McFarland Johnson  
 Date: August 31, 2011  
 By: J. Santacruz

<b>JOHNNIE BROOK ROAD PROFILE</b>	PROJECT NAME: RICHMOND	PLOT DATE: 8/25/2011
	PROJECT NUMBER: STP-RS 0284(III)	DRAWN BY: C.A.K.
	FILE NAME: z90c092_PRO_07_14.dgn	CHECKED BY: D.E.G.
	DESIGNED BY: B.T.H.	SHEET 18 OF 46
	DWG. NO.: PR-7

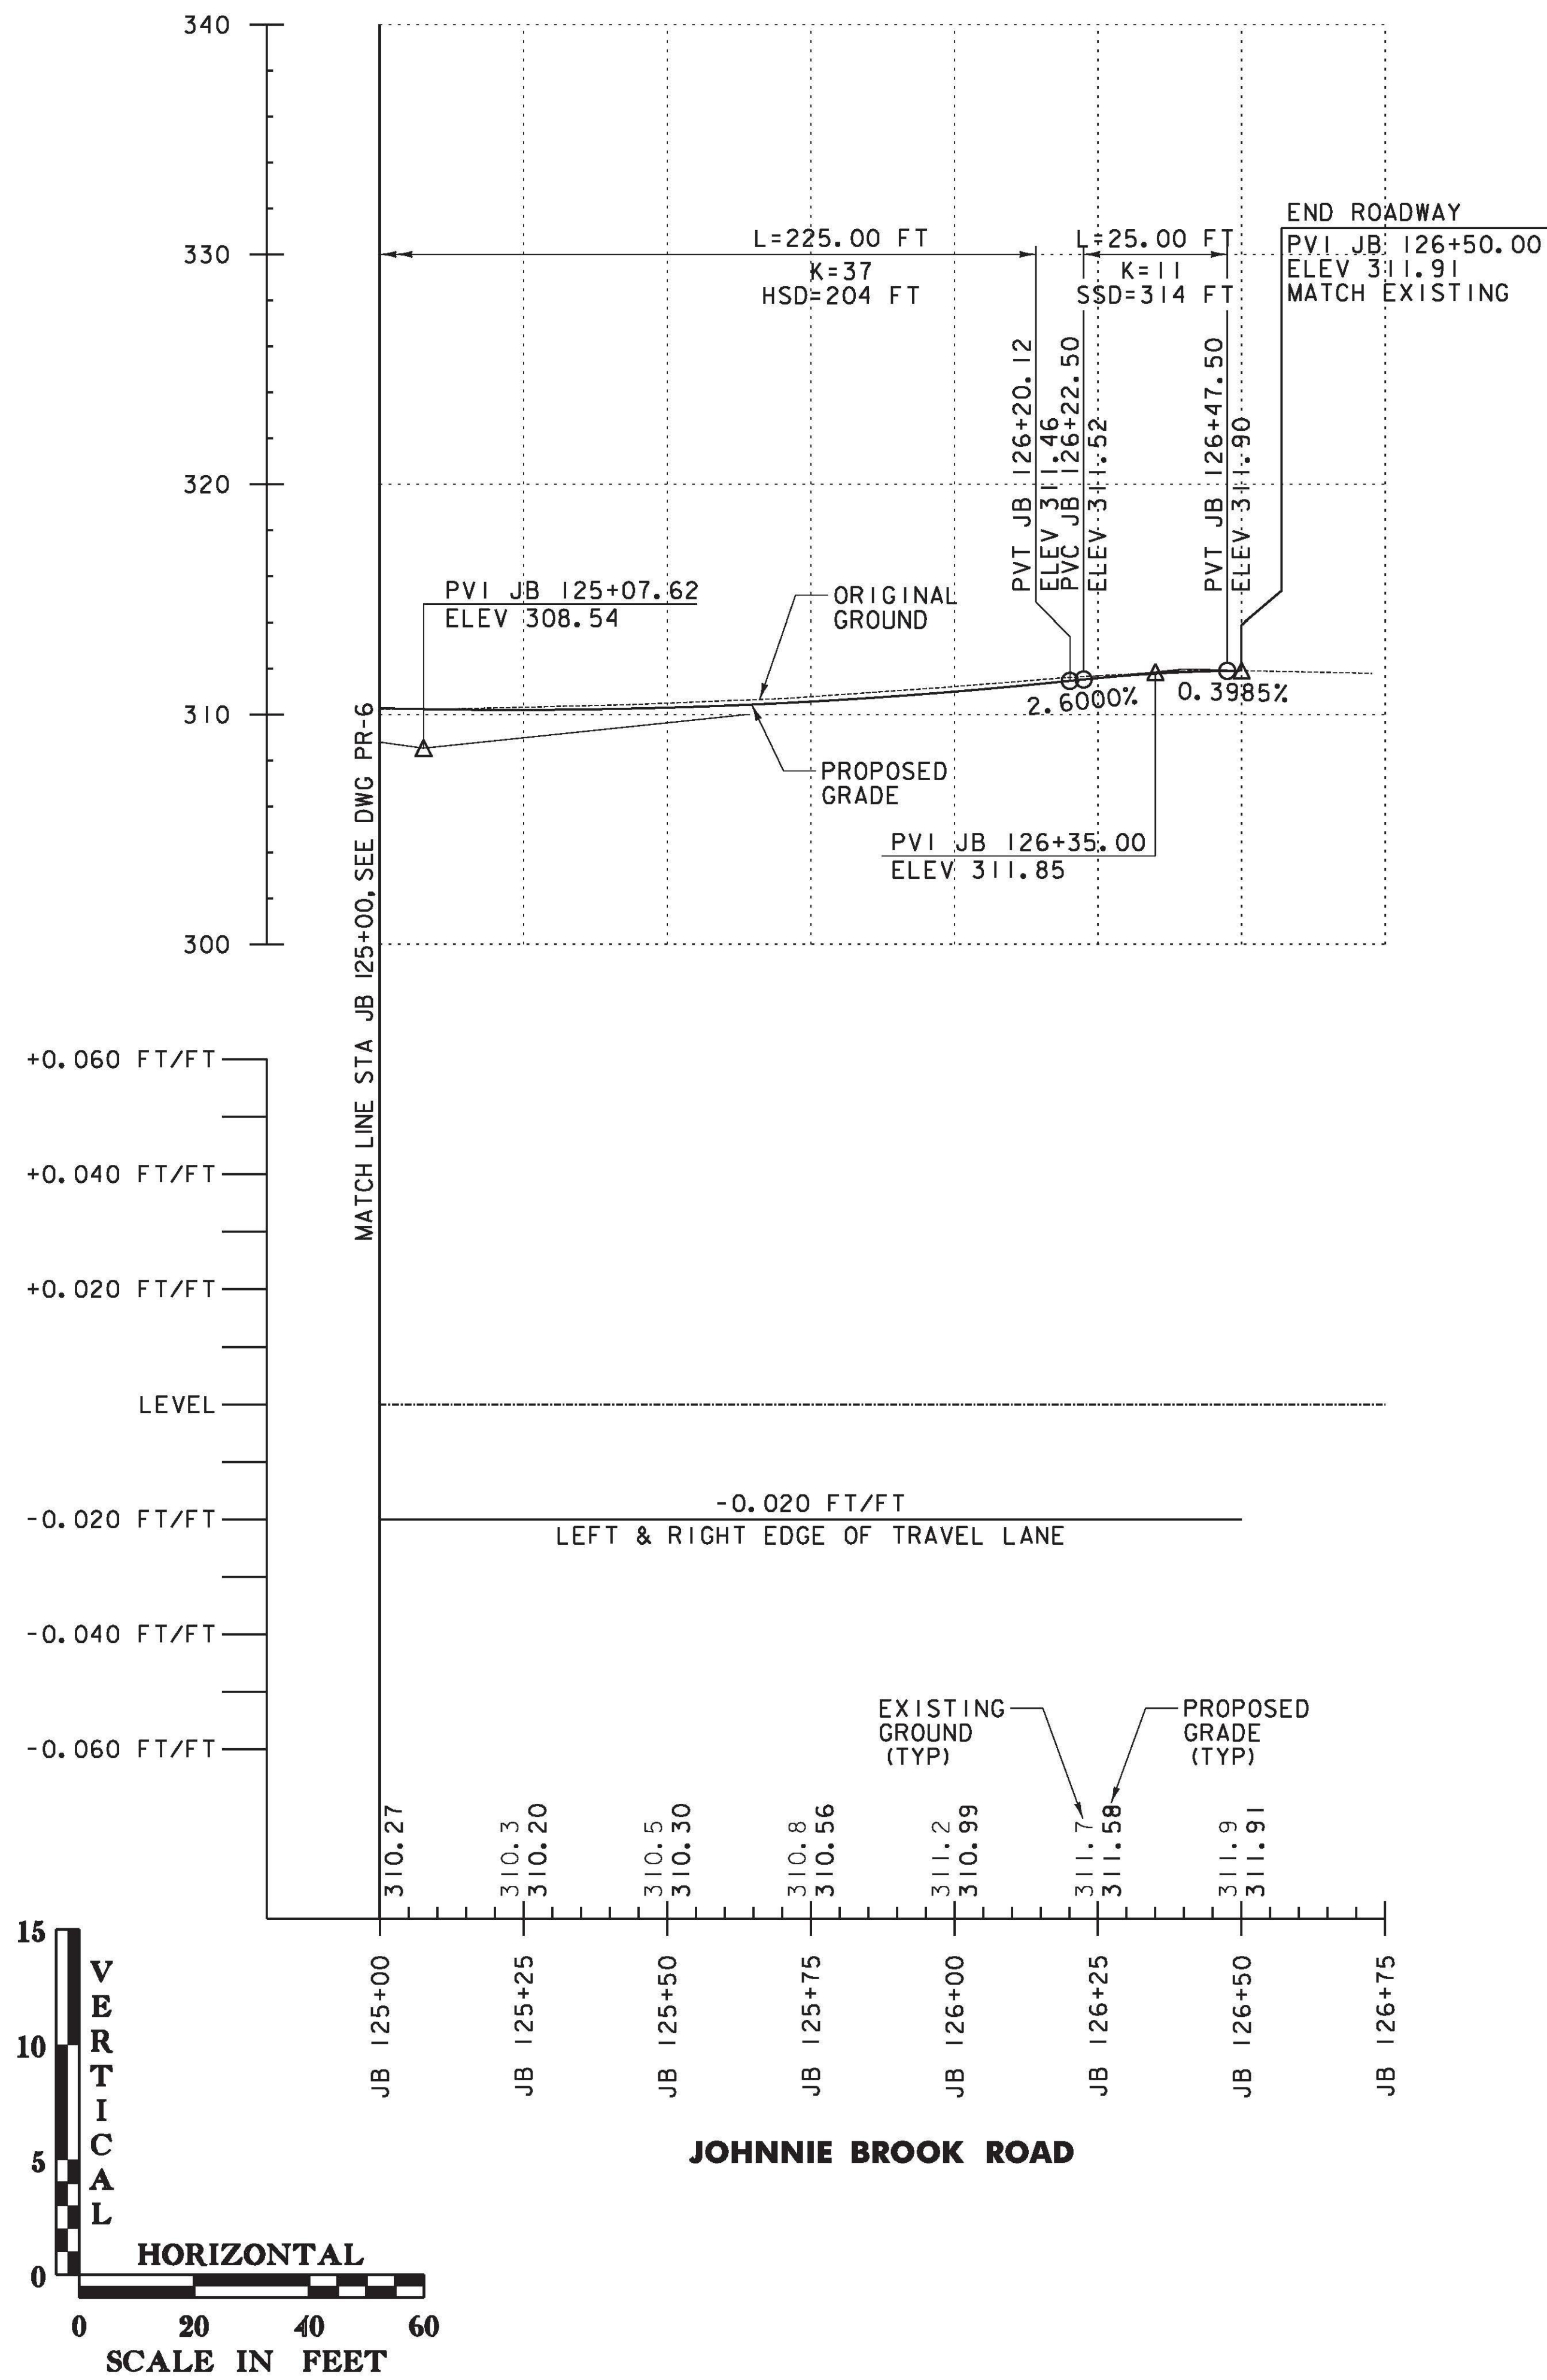
X Reviewed	_____ Furnish As Corrected
_____ Rejected	_____ Revise and Resubmit
